**DUTCH BARN AT PLAS
FARM
CILYBEBYLL**

**STRUCTURAL SURVEY
AND APPRAISAL
REPORT**

APRIL 2022

***ateb*Consult**

Fig.2

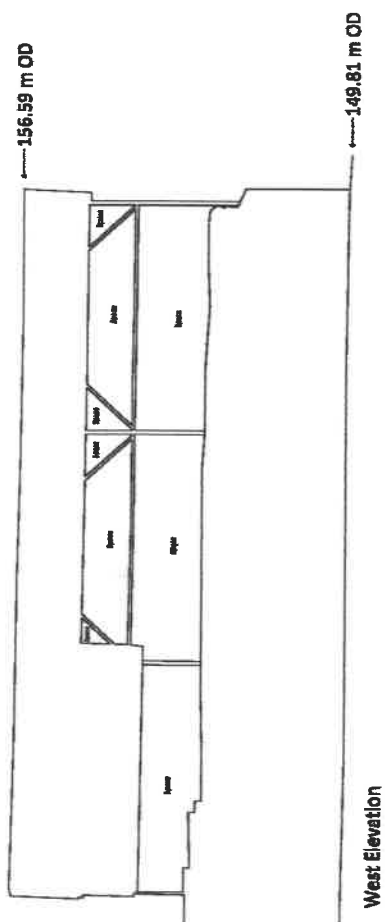
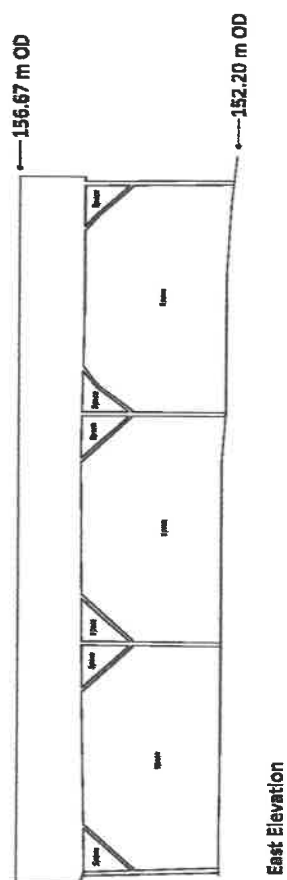
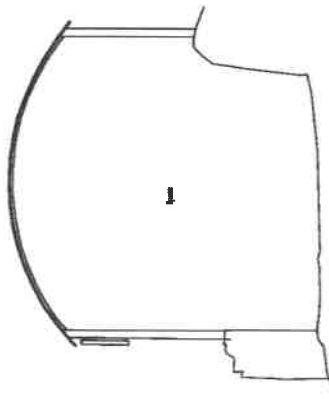
The barn is some 14.2m long and 6.2m wide as shown on the survey drawing fig.2

- 6.2.1 Heights of existing walls** – these are detailed on the attached survey drawings and as noted above are some 2400mm high
- 6.2.2 Existing Retaining walls** – it is proposed to keep the existing walls and build a new retaining wall inside to provide add support and allow waterproofing measures.
- 6.2.3 Extents of walls** –as described in report and shown on plans
- 6.2.4 Design of new walls** –as appendix C
- 6.2.5 Walls /retention of ground away from Building** – there are already existing masonry walls in these areas and no add walls are deemed necessary – the existing walls need to be cleaned of vegetation and made good as appropriate
